**The Corporation of the Municipality of Mississippi Mills
Public Works Advisory Committee**

1. Pakenham pedestrian crossovers

Pakenham Pedestrian Crosswalks

Road Engineering Design Guidelines
10.0 Curb Extensions

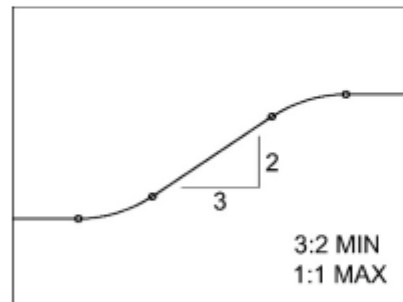
- ▶ Curb Extension Guidelines from the City of Toronto; draws into question the legitimacy of building bump outs with mountable curbs

Figure 17 – Example Curb Extension

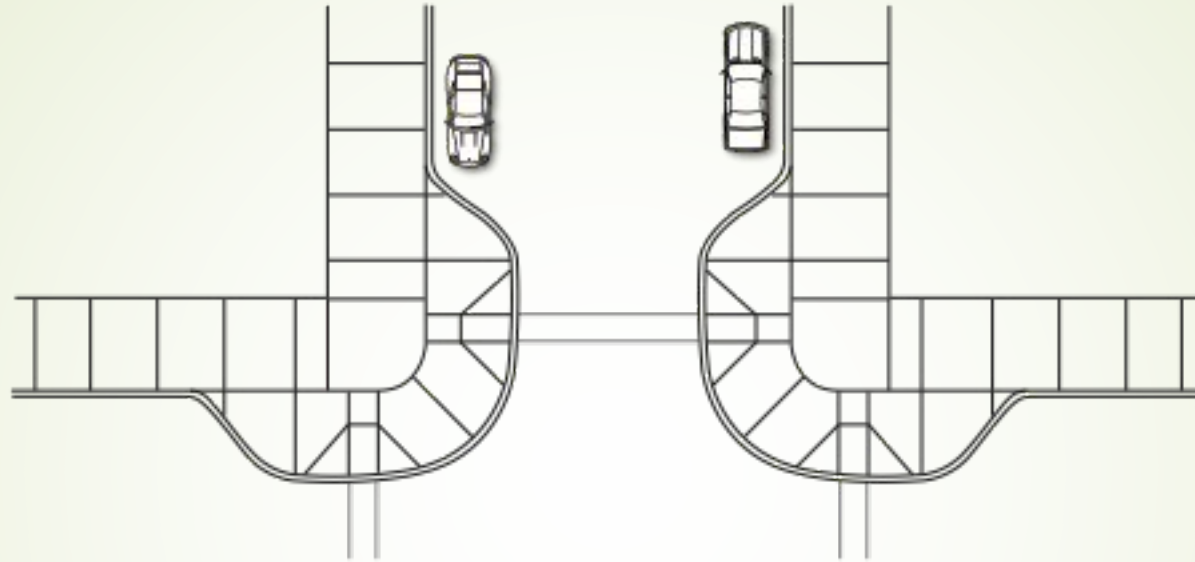
- ▶ Bump Out design was based on Ministry of Transport Pedestrian Crossings Facilities Book 15 guidelines
- ▶ page 41 clearly states that curb extensions or Bump Outs should not be used where there is concern for large vehicles driving over the pedestrian staging area; the proposed design is a direct contravention to Book 15 design standard

- Providing turning radii sufficient for commercial vehicles or transit vehicles to prevent them from mounting the curb and putting pedestrians at risk
- The delineation requirements of bicycle lanes
- Restricting parking in close proximity to the curb extension and parking within the boulevard on the curb extension to improve visibility of pedestrians and drivers
- Local requirements for snow removal

Figure 2 - Type B PXO Diagram

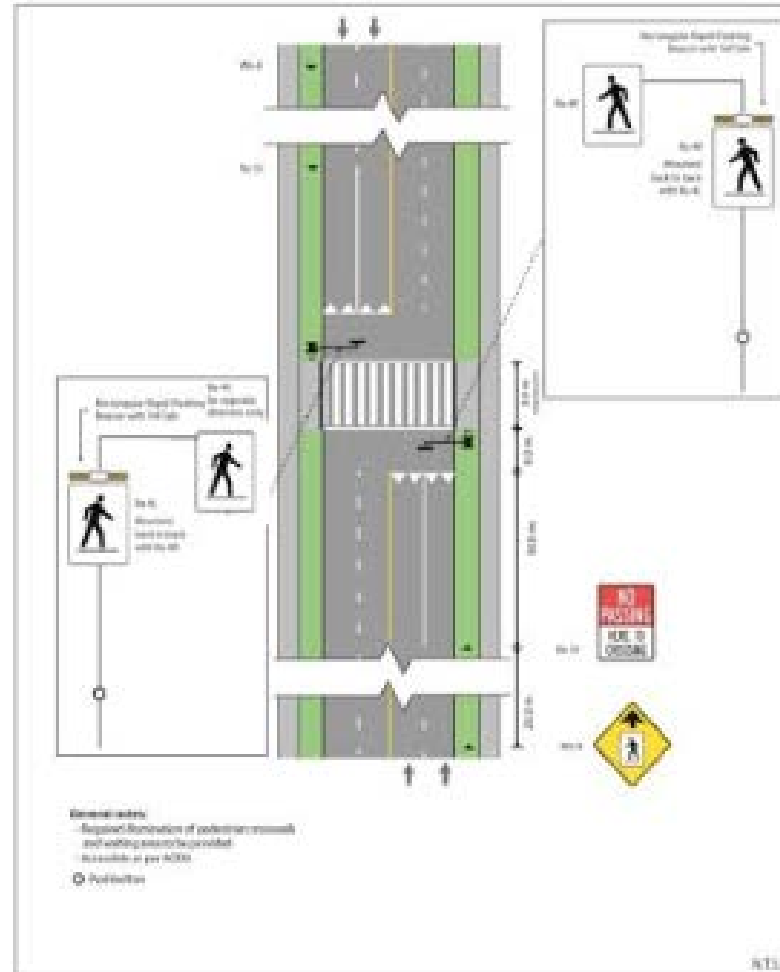
PWAC Proposed Cross Walk Option

Type B treatments are typically located on medium volume, medium speed, and single or multi lane roadways such as major collectors, arterials and high volume multi lane roundabouts. They typically consist of roadside mounted signs with overhead signs and rapid flashing beacons on top of the roadside mounted signs.
